Tech Tips

TT 17-14-01

2014 Routan 3.6 Oil Pressure Light ON and P06DD is Stored

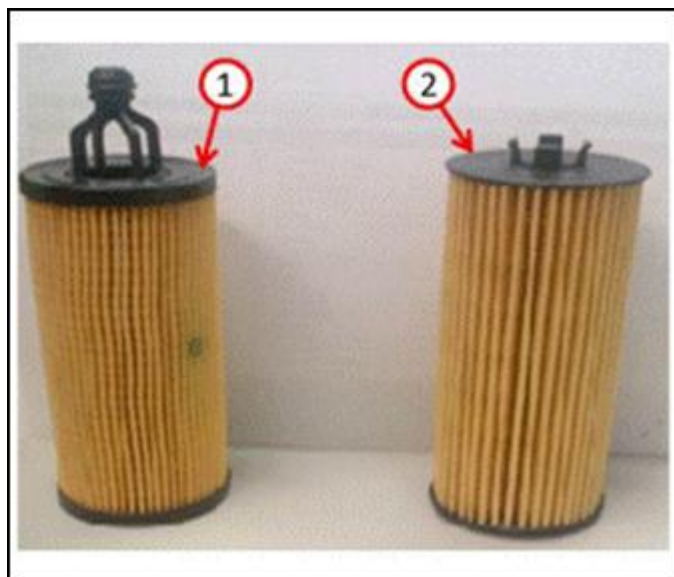
A change was made to the engine Oil Filter Adapter (OFA) for 2014 Model Year vehicles that resulted in a change in the oil filter element. It is important to note that the two different designs are **Not** interchangeable. Failure to install the correct oil filter **WILL** result in permanent engine damage.

- When replacing the filter, use only the o-ring included in the filter package. Failure to do so WILL result in leakage and possible Oil Filter Adapter damage.
- Also DTC P06DD will result due to incorrect filter application.

Please remove and inspect the oil filter for correct filter installed.

1 - 2014 Model Year and Later (P/N 7B0115562A).

2 - 2013 Model Year and Prior (P/N 7B0115562B).
